ADDENDUM NO. 04

July 30, 2026

High School Addition & Renovation
Jr. High Addition & Renovation
Intermediate School Controls Renovations
Primary School Controls Renovations
Softball Concessions
Ellettsville, IN 47429

This Addendum consists of Pages ADD 4-1 through ADD 4-4 and attached Lancer Associates Architecture Addendum No. 4 dated July 30, 2026, consisting of ten (10) pages and 53 drawings.

2 S100B.3 FOUNDATION PLAN - UNIT B.3
SCALE: 1/8" = 1'-0"

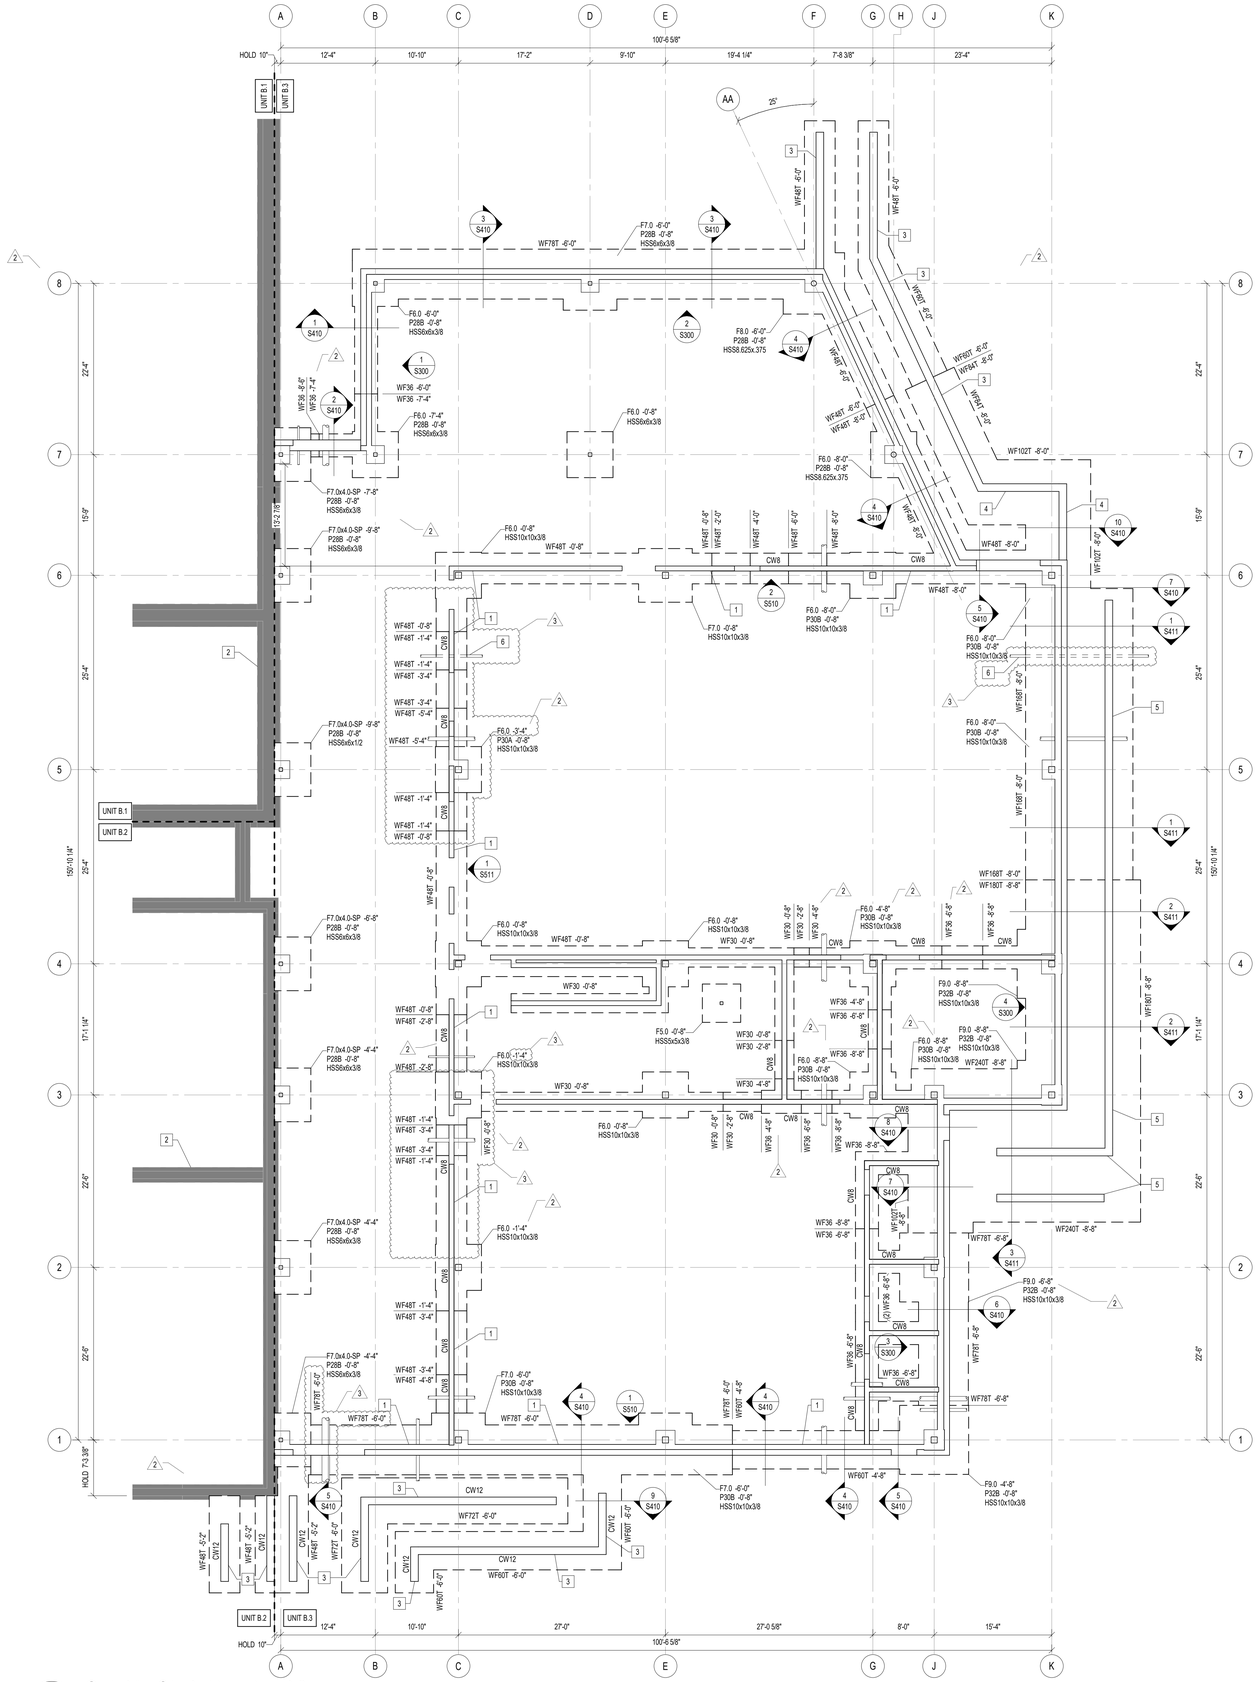
1. S100B.3 – Foundation Plan - Unit B.3
   a. Adjusted approximate locations of underground utilities on plan. Updated approximate footing step locations and elevations based on Civil field investigation.
   b. Added key note to sleeve existing deep sanitary line to remain per new typical detail.
   c. Added new pier type for (1) instance on plan.
2. S400 – Typical Foundation Details
   a. Added new typical detail for sleeving pipe under new wall footing.
3. Drawing AD101E2:- Demolition Plan – First Floor – Unit E2
   a. Added notes for the demolition of the display case and bulkhead
4. Drawing D141R – Demo Roof Plan
   a. Added Keynote 7
5. Drawing A101E2: - Floor Plan- First Loor Unit E2
   a. Added notes for infill, added tack board

1 REFLECTED CEILING PLAN - UNIT FIRST FLOOR - E2

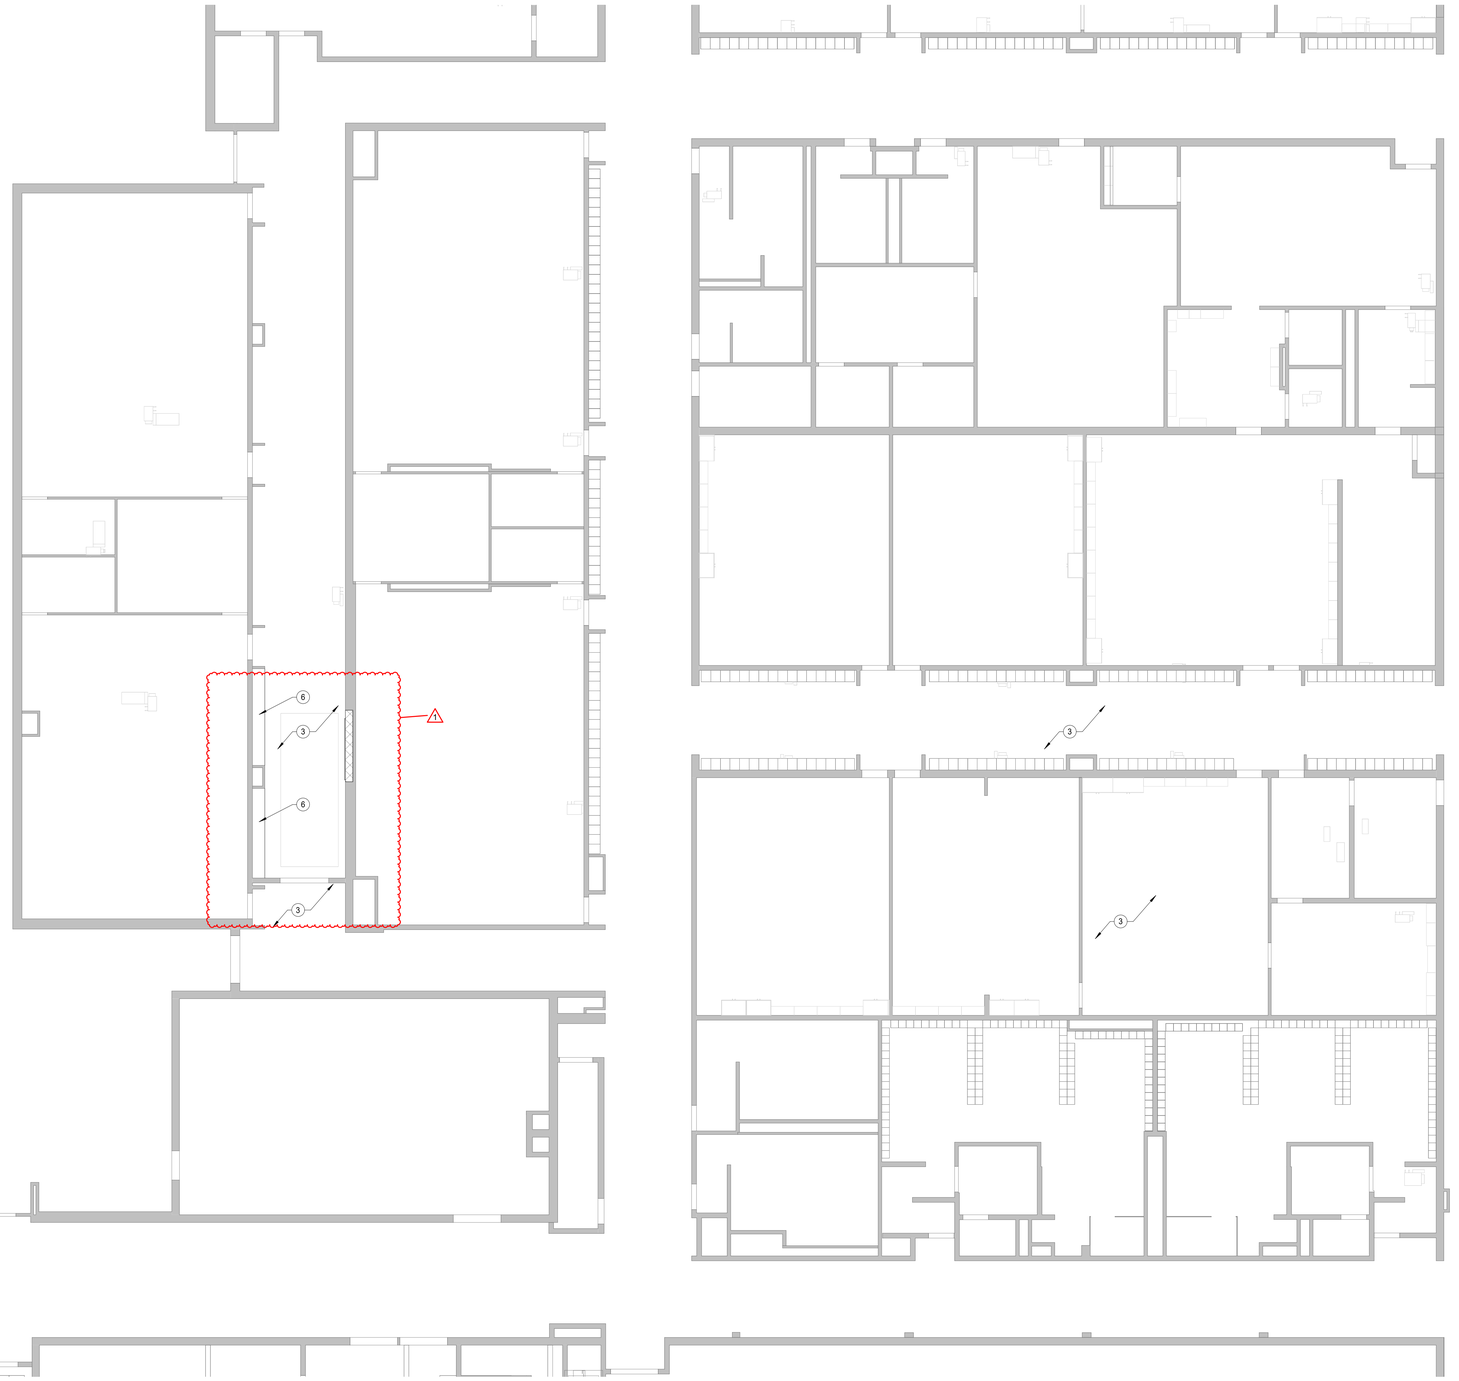
6. Drawing A121E2 – Reflected Ceiling Plan – First Floor Unit E2
    a. Added notes for patching of the bulkhead
7. Drawing A122B3 – Reflected Ceiling Plan – Second Floor – Unit B3

1 REFLECTED CEILING PLAN - SECOND FLOOR - UNIT B3

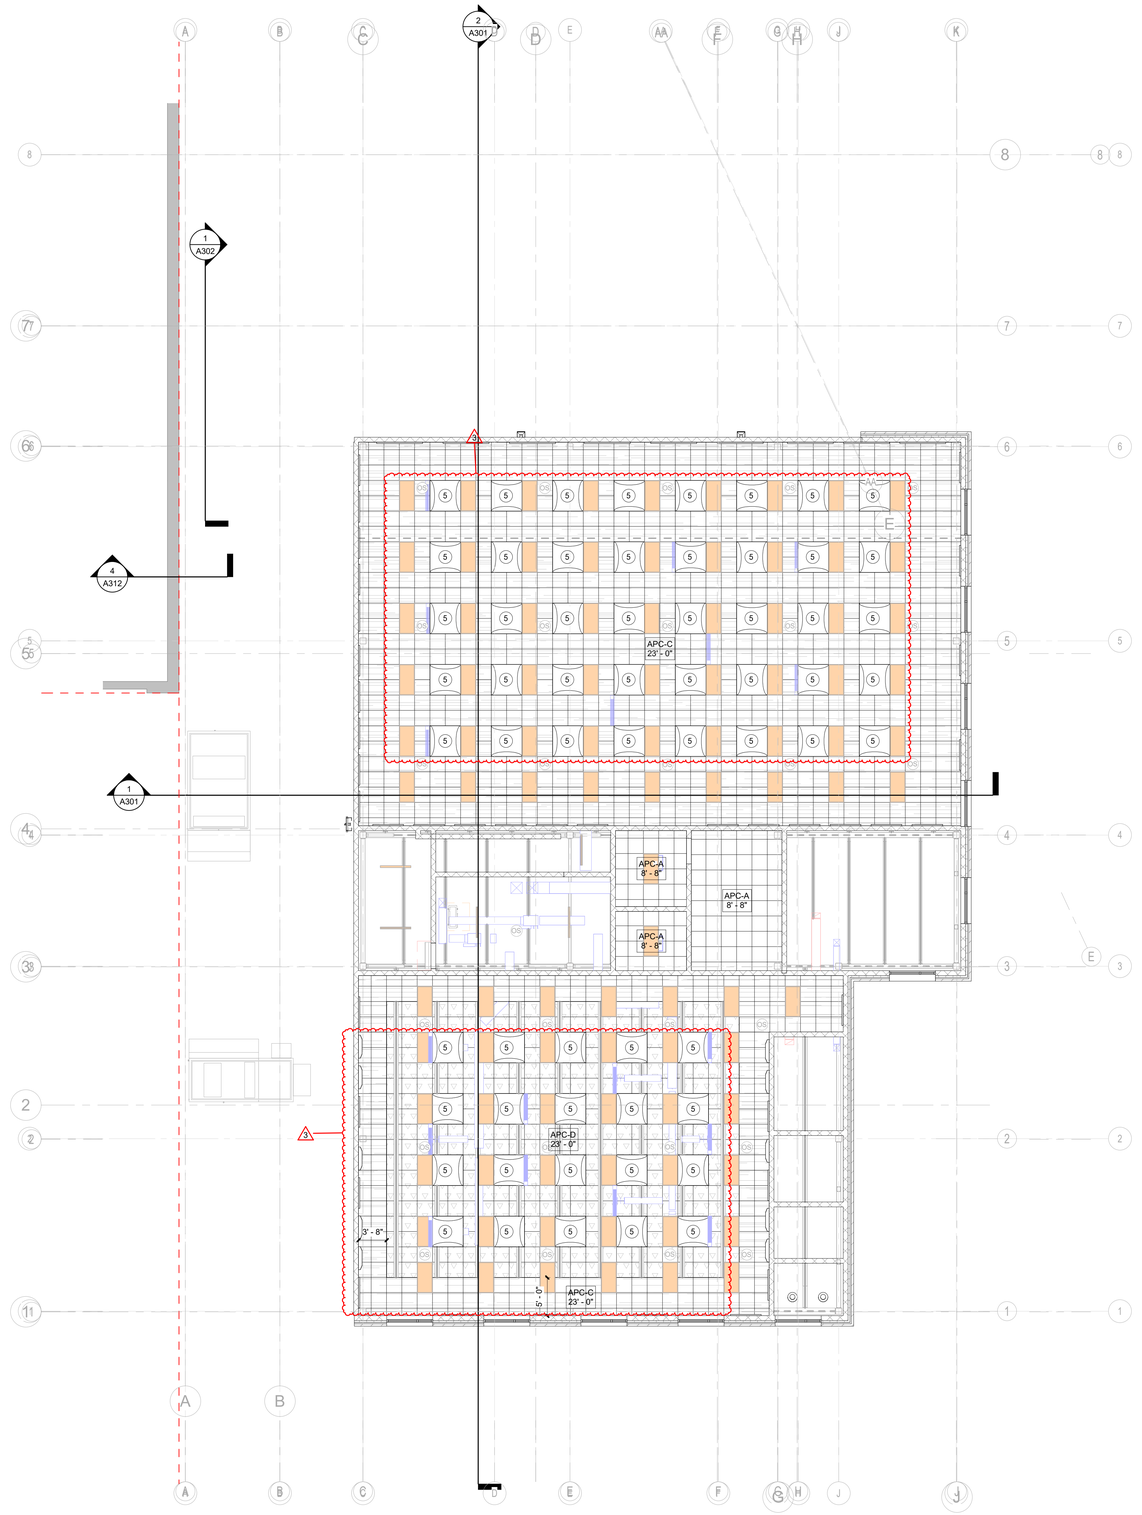
a. Added keynote 5 to identify ceiling diffuser panels
8. Drawing A141R – Roof Plan
    a. Added Keynotes, Section Cuts and changed location of the expansion joint

A141R

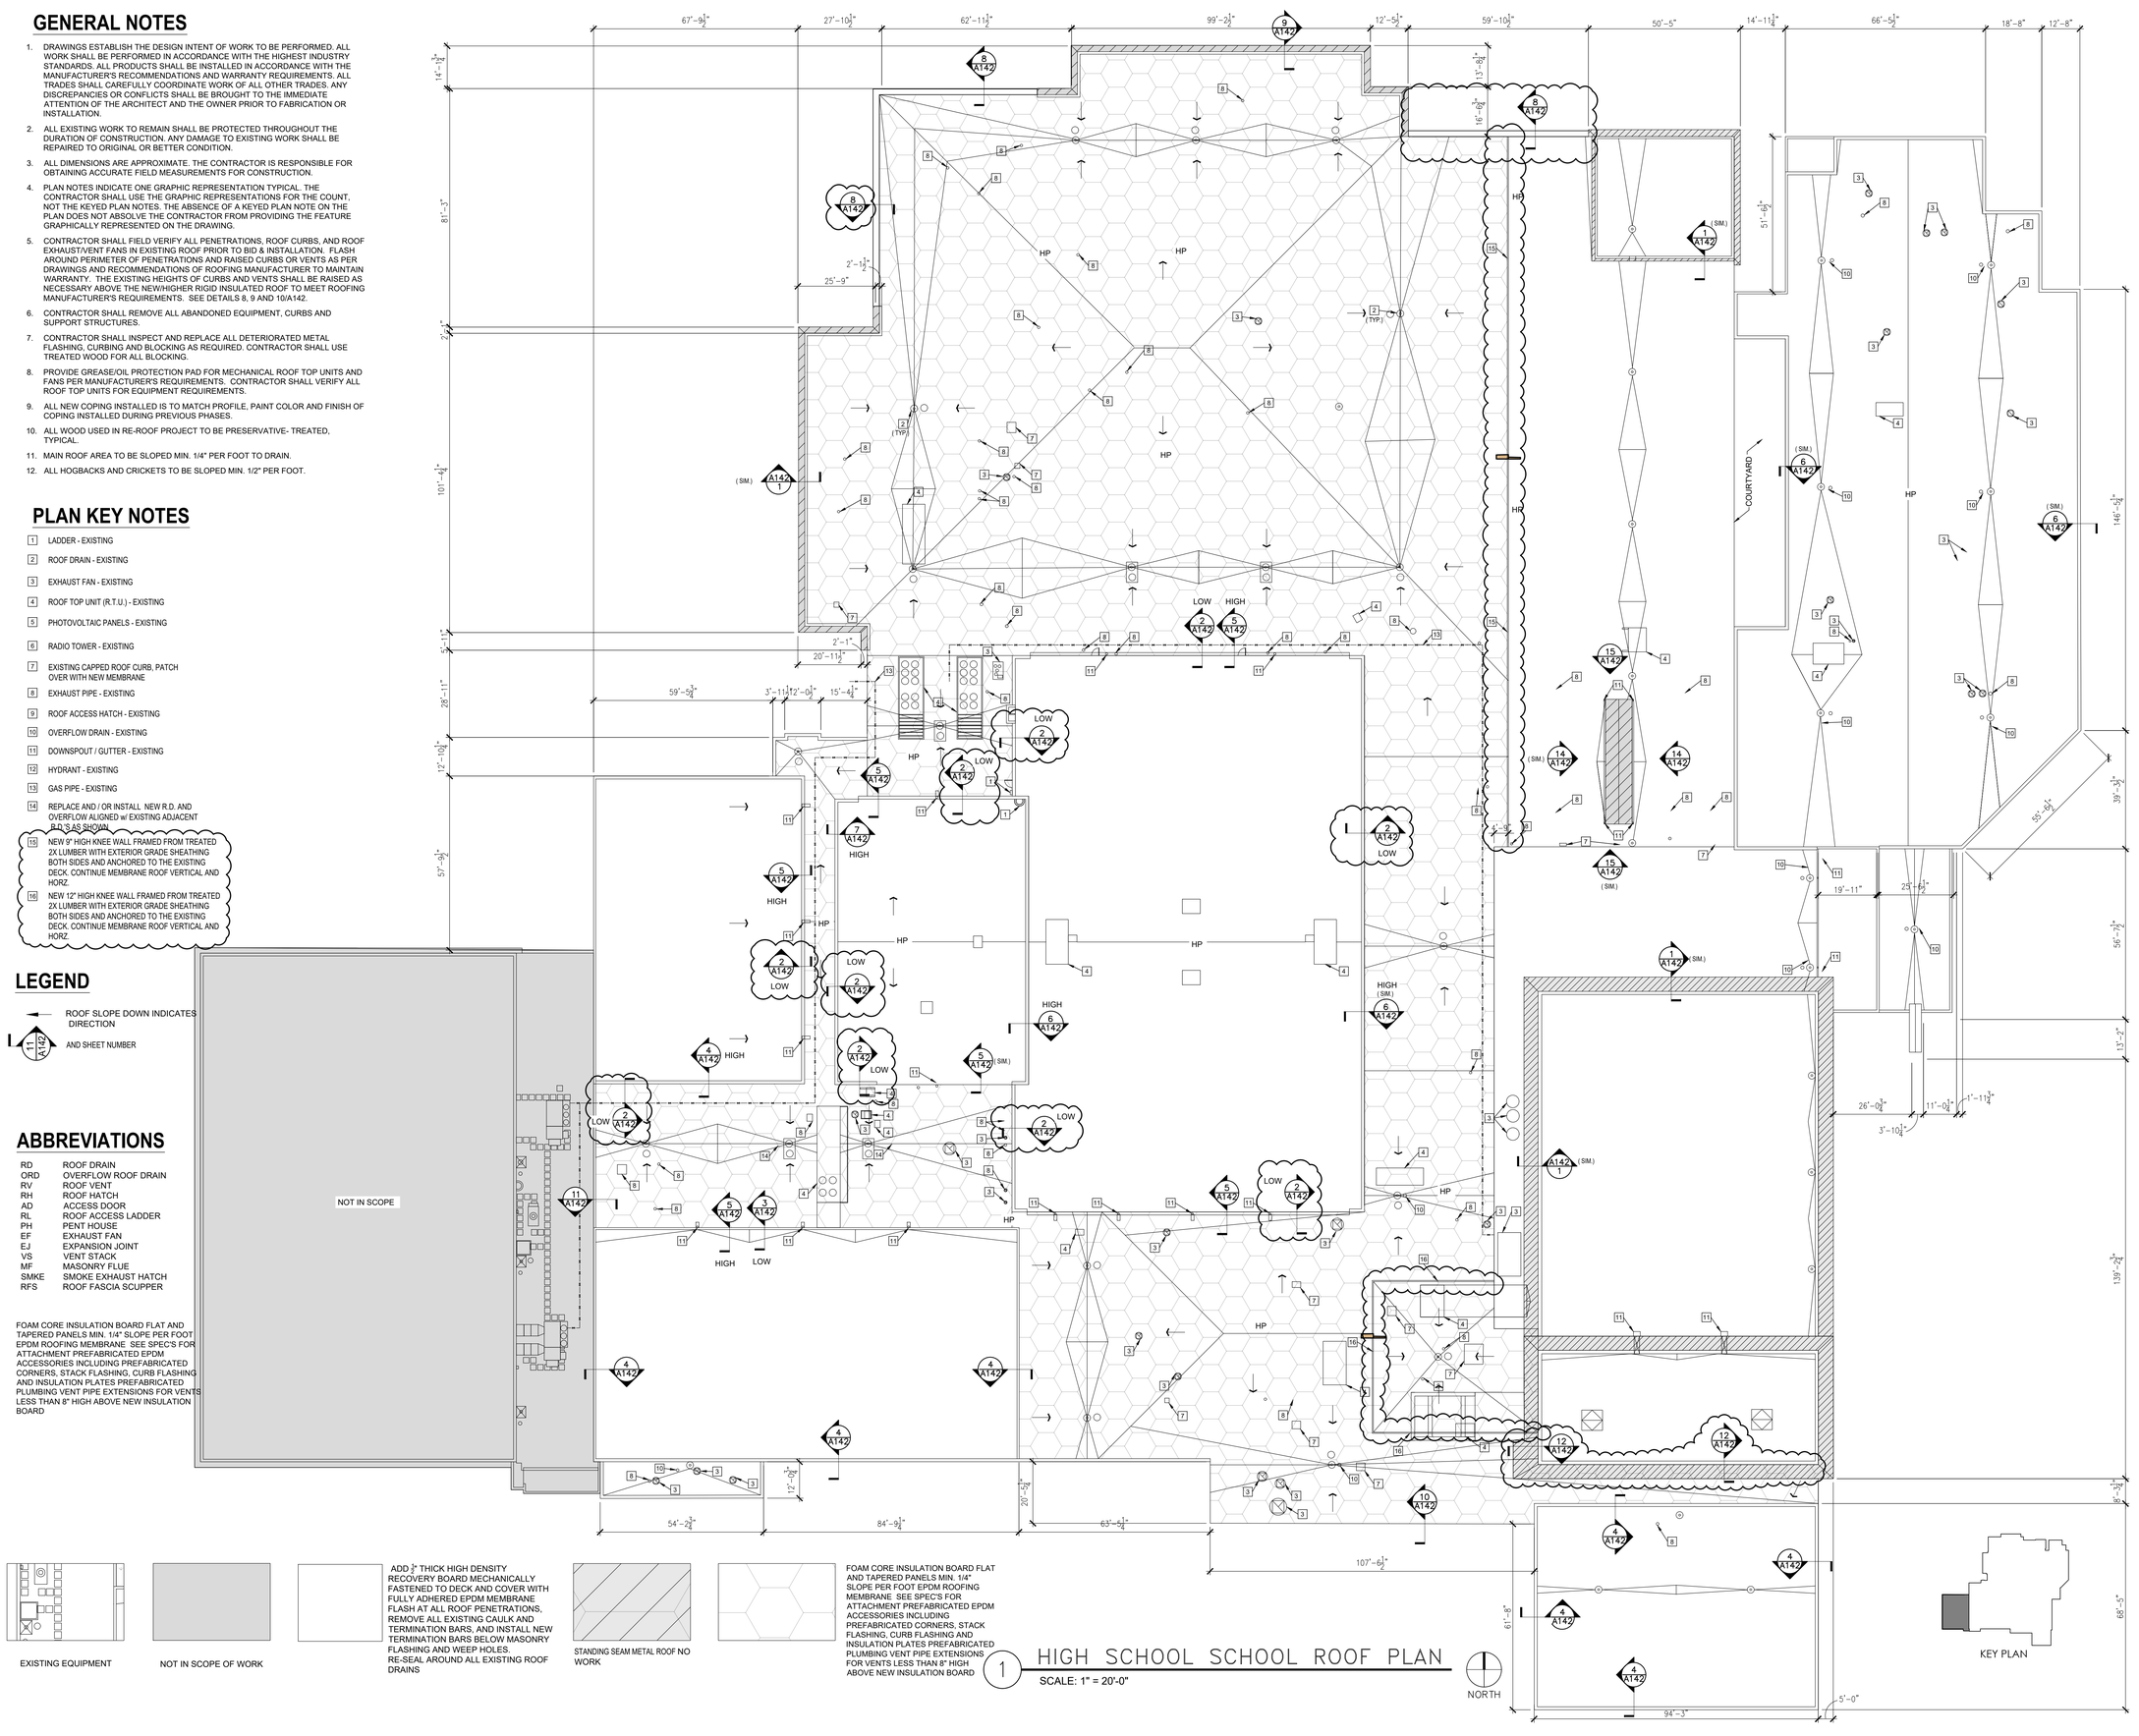
6. High School Drawing Sheet A141R – Roof Plan. See section cut 2/A142. Include in Bid package #3 bid:
   a. Shoring and removal of existing limestone.
   b. Provision and installation of new concrete masonry veneer.
   c. Provision and installation of new flexible adhered flashing in wall cavity.
   d. Any other materials or activities required for a complete functioning system.
   e. Installation of new metal flashing to be provided by Bid Category #5 roofing.
   f. Coordinate with Bid Category #5 Roofing Contractor. Total reroof (roof removal to deck) work is to be completed during summer 2027.

9. High School Drawing Sheet A141R – Roof Plan. See section cut 2/A142. Include in Bid package #5 bid provision of all metal flashing and counter flashing to Bid Category #5 Masonry.

3 Detail 12
SCALE: 1 1/2" = 1'-0" REF. 1 / A102B3

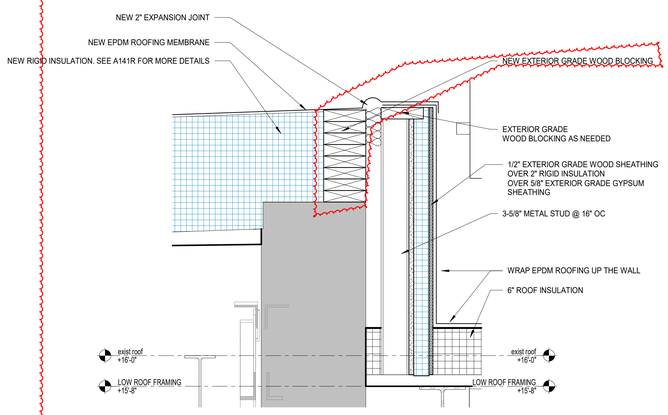
4. Clarification to Addendum #3.
    a. High School detail 12/A312: Provide and install metal studs and gyp. bd. sheathing.
    b. Jr. High School details 1 and 6/A311, and 1/A312: Provide and install metal studs and gyp. bd. sheathing.
    c. Provide and install metal studs and gyp. bd. sheathing. at any similar details.

a. Changed Detail 11 to reflect metal panels visible on elevations
    b. Added wood blocking to Detail 12
    c. Added View
14. Drawings A751 and A752

4 CASEWORK TALL WARDROBE SECTION

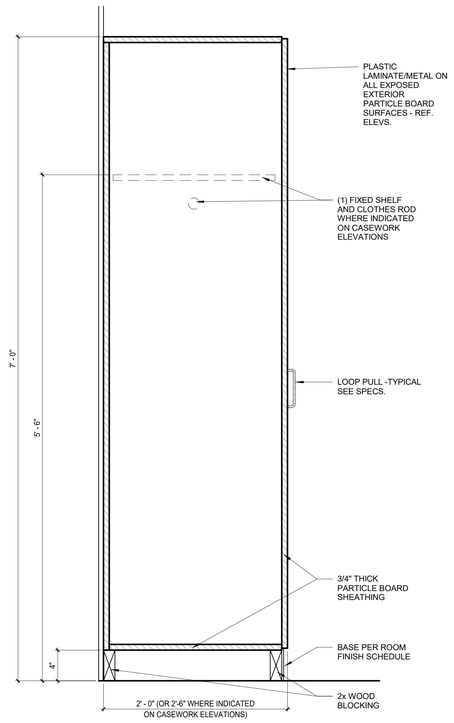
Q: At the high school for elevation 5 are the cabinets on the left supposed to be open metal lockers? Section details call out laminate but the note calls for metal
A: See attached revised section detail 4/A765. Open metal lockers on the left in elevation 5/A762 are correct.

a. Revised text callouts to incorporate metal as finish material for detail 4/765.
18. Drawing PF102B3
    a. Update storm and sanitary pipe locations/inverts. Added temporary fire protection lines (for reference only)
